ADDENDUM NO. 1

**Three Rivers Community Schools – New Transportation Facility
58420 Haines Road
Three Rivers, MI 49093**

NEW TRANSPORTATION FACILITY

ADDENDUM 001

2
A4.01 EAST EXTERIOR ELEVATION
1/8" = 1'-0"

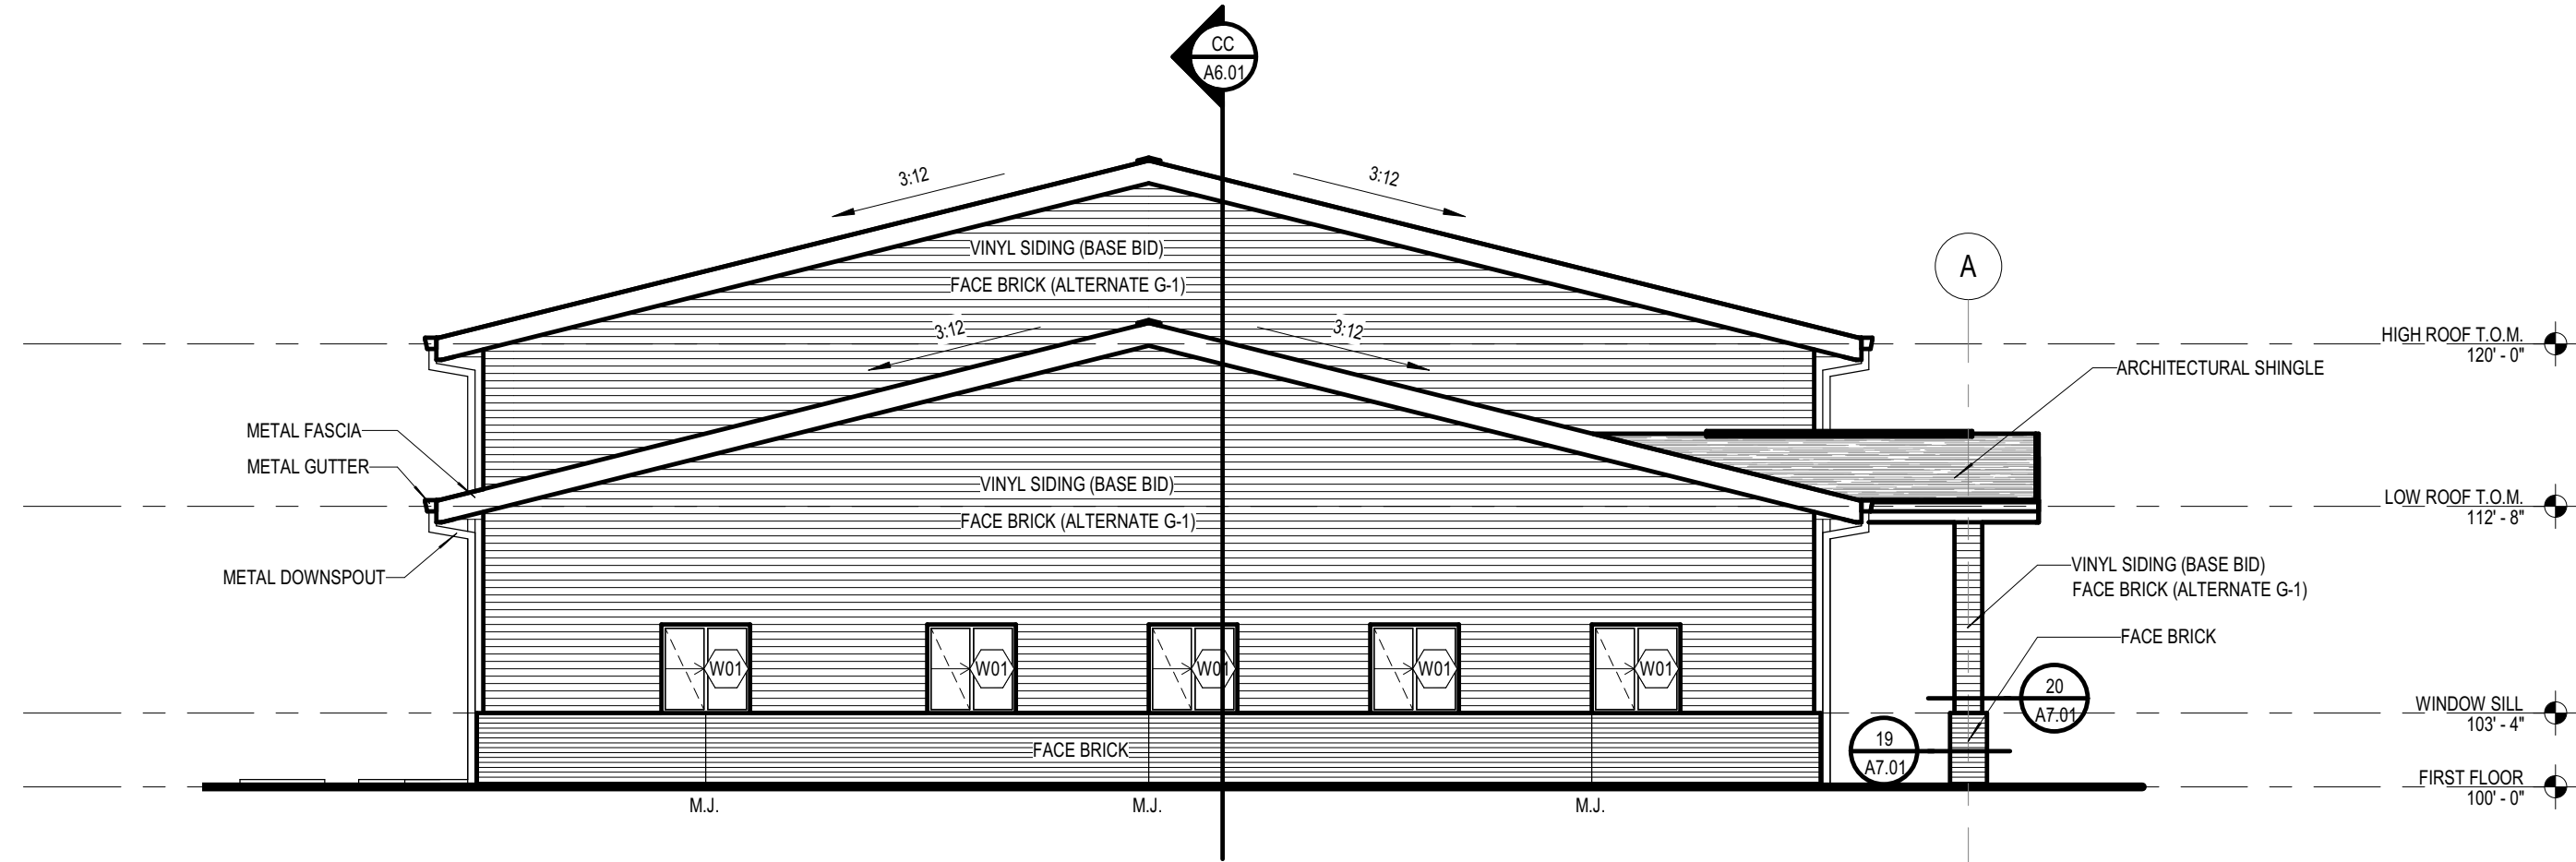
Added louver detail callouts to East Exterior Elevation.

FIRST FLOOR POWER & COMMUNICATIONS PLAN
1" = 10'-0"

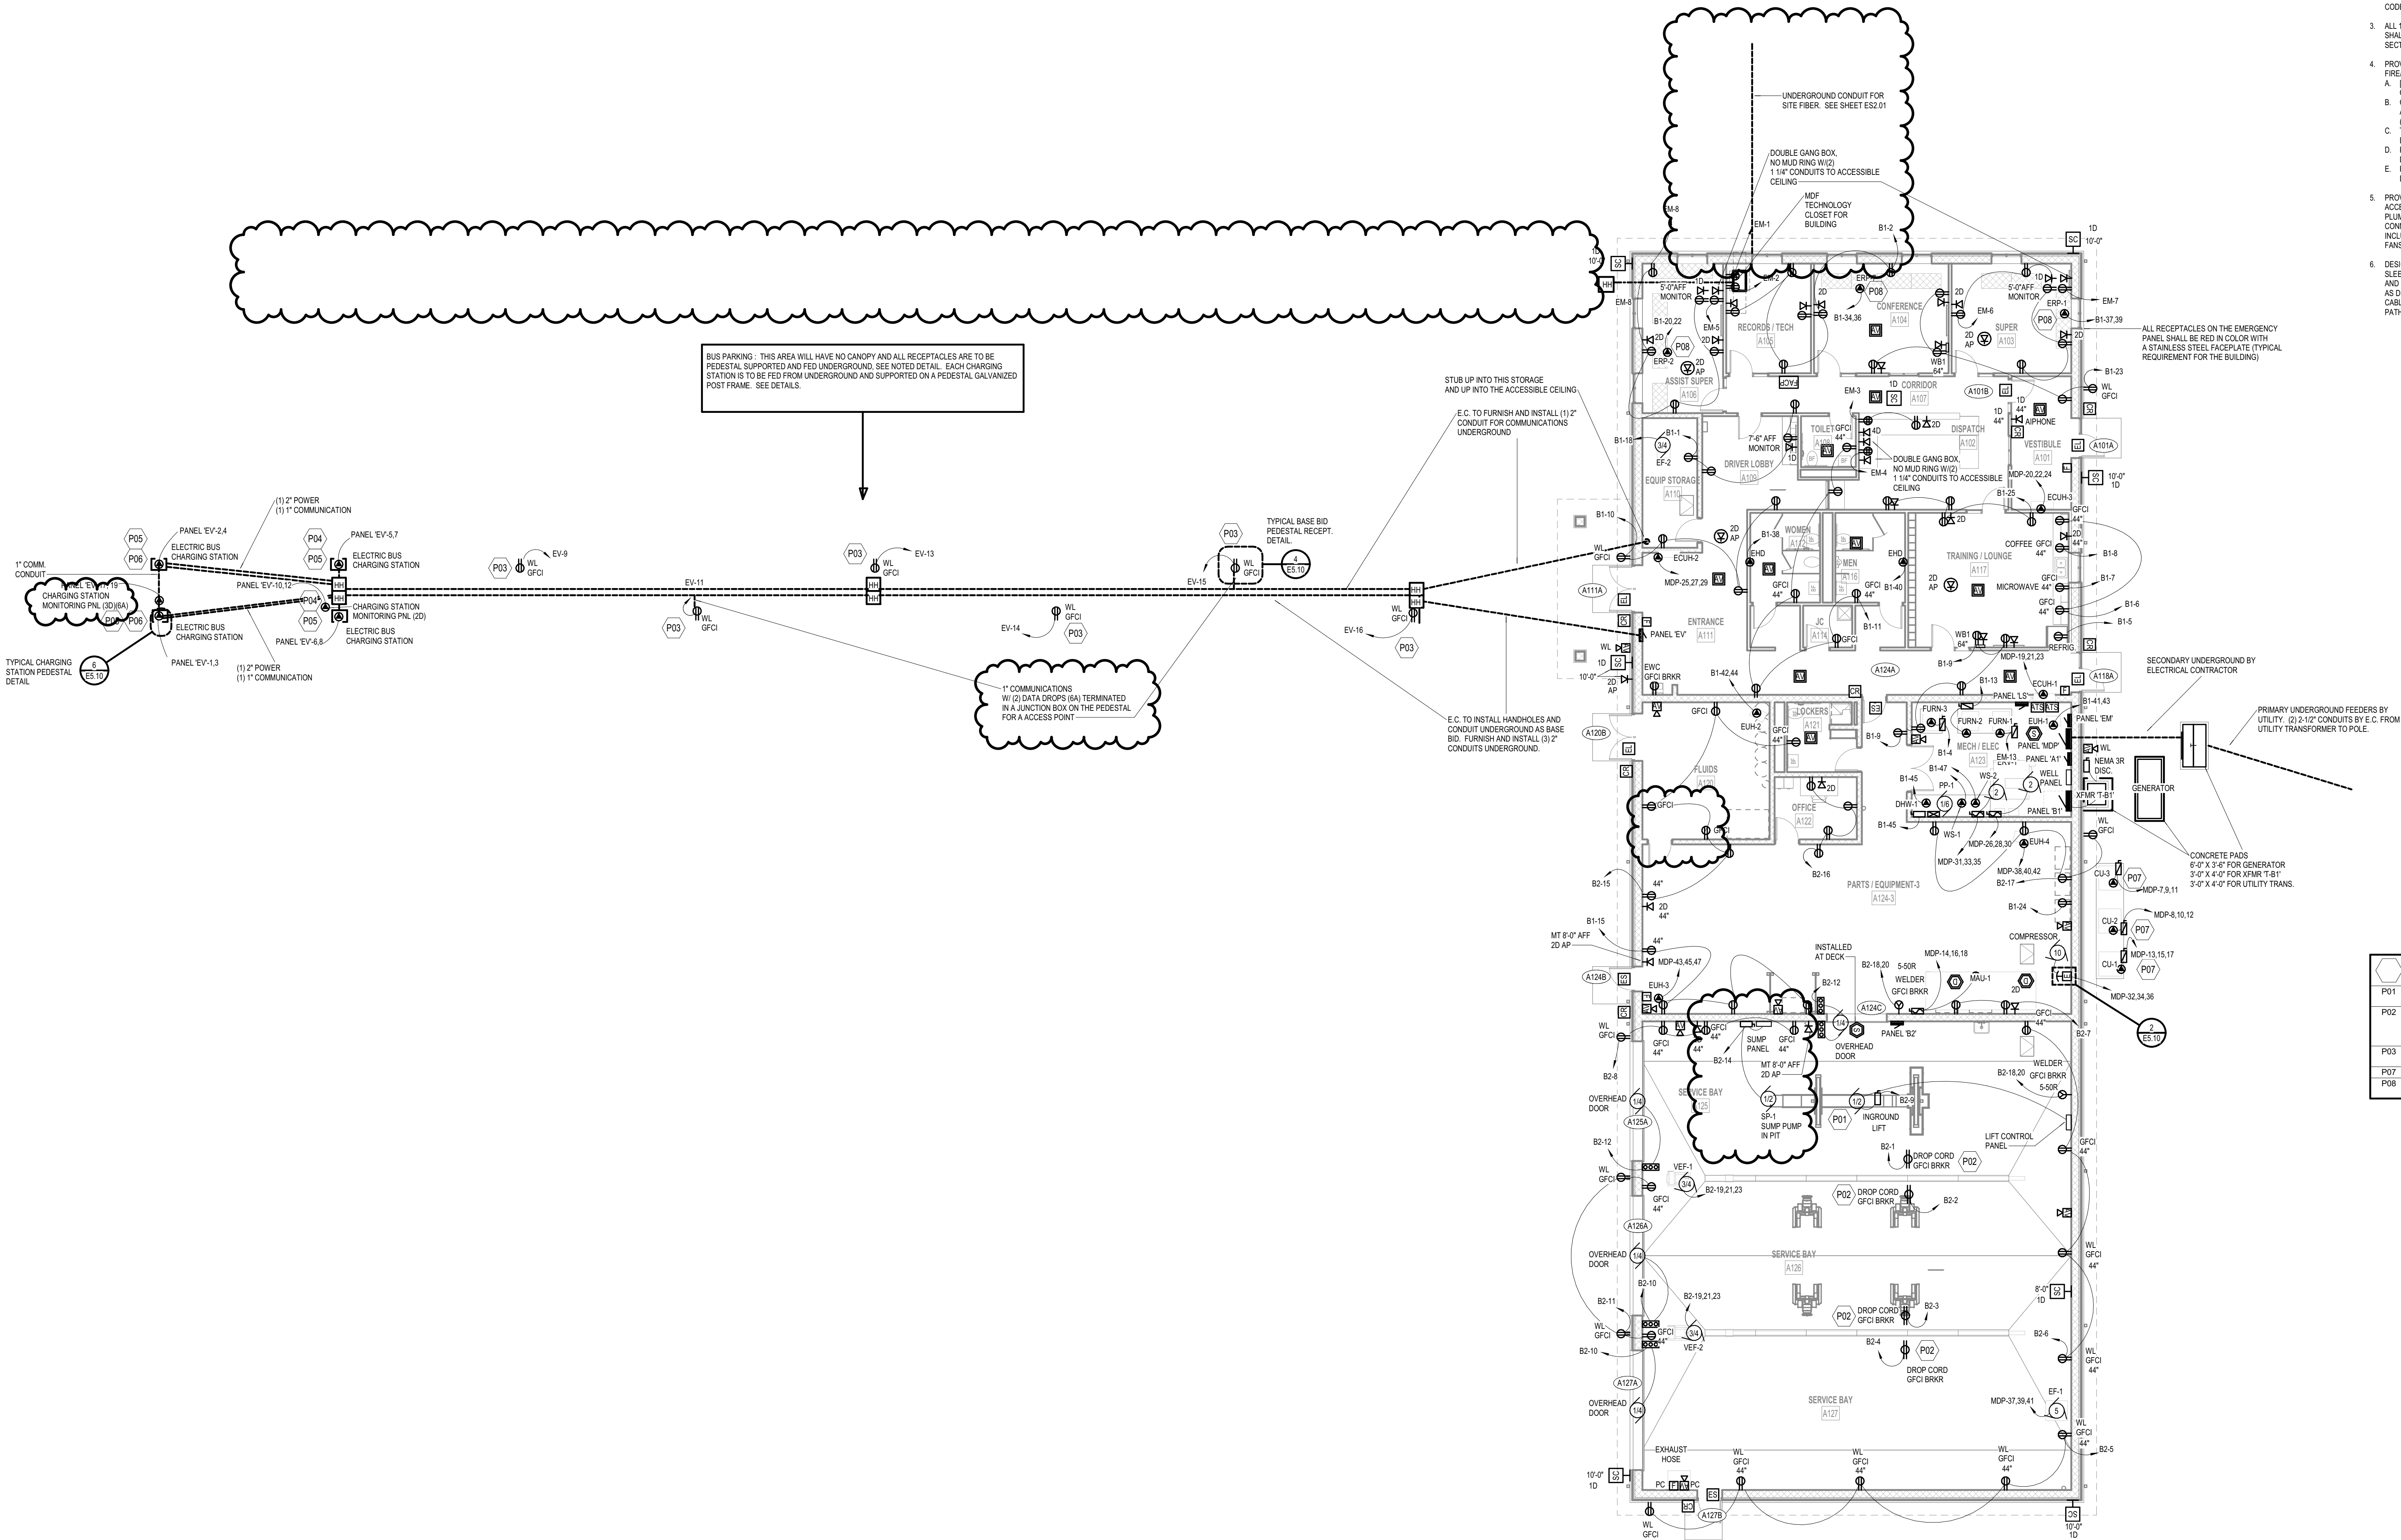
Refer to the plan for structured communication cabling changes, sump pump relocation and underground conduit removal from plan.

SITE ELECTRICAL PLAN

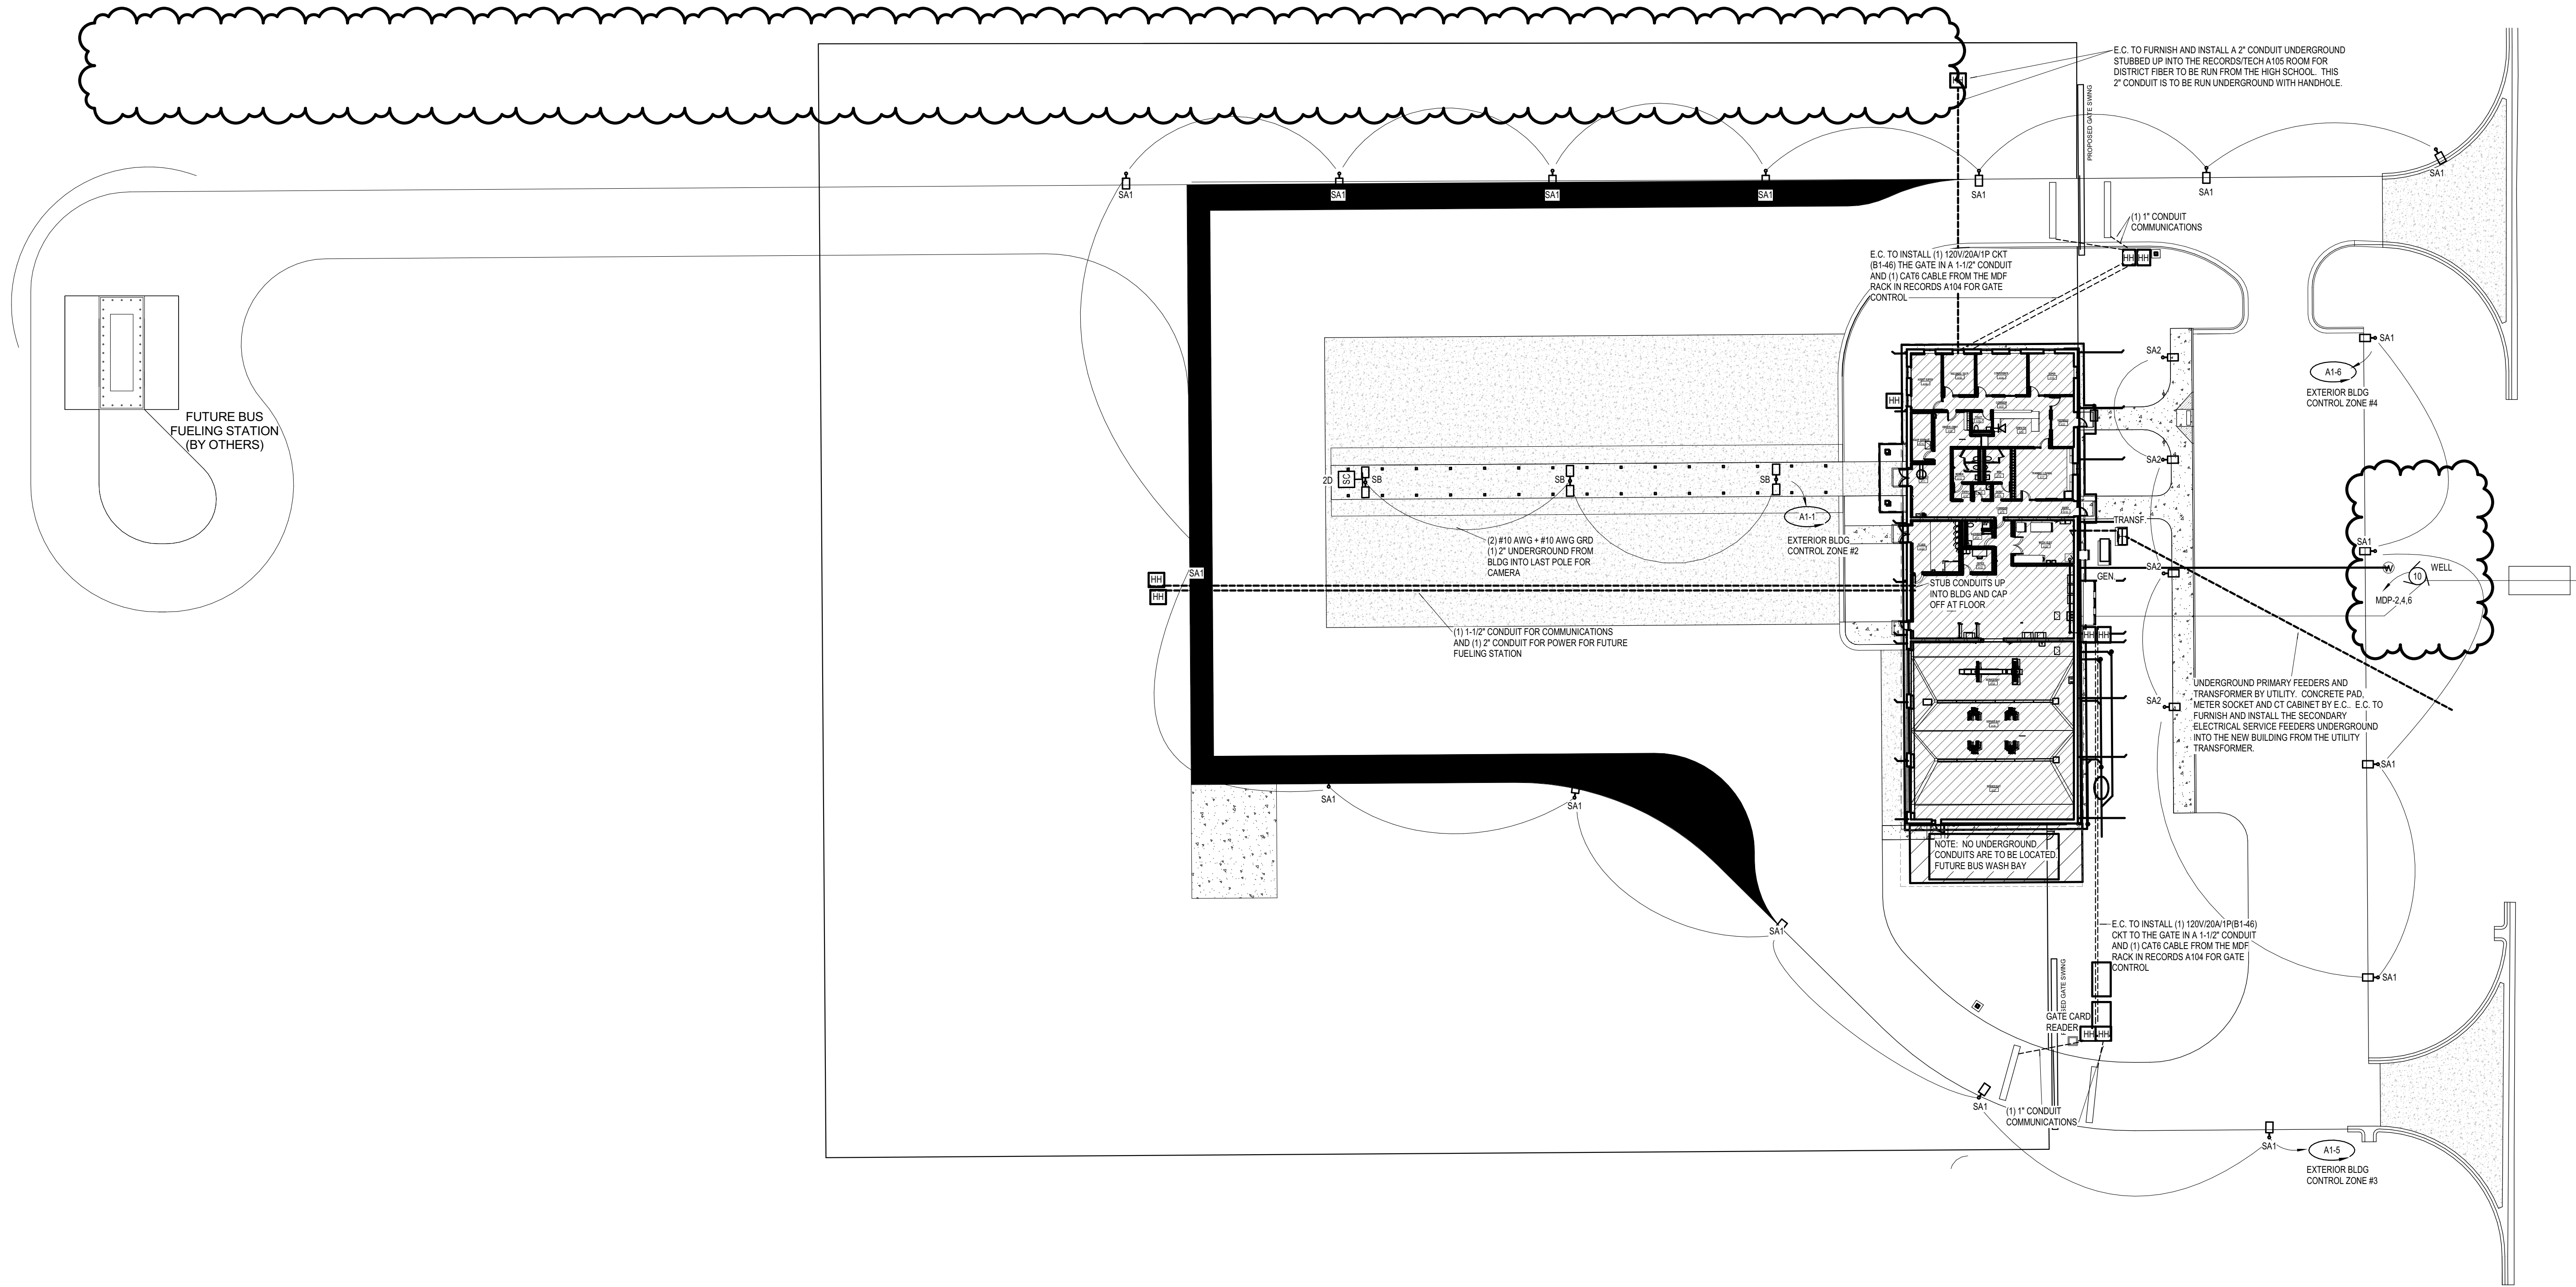
Refer to plan for changes to the well location and the removal of underground conduit.
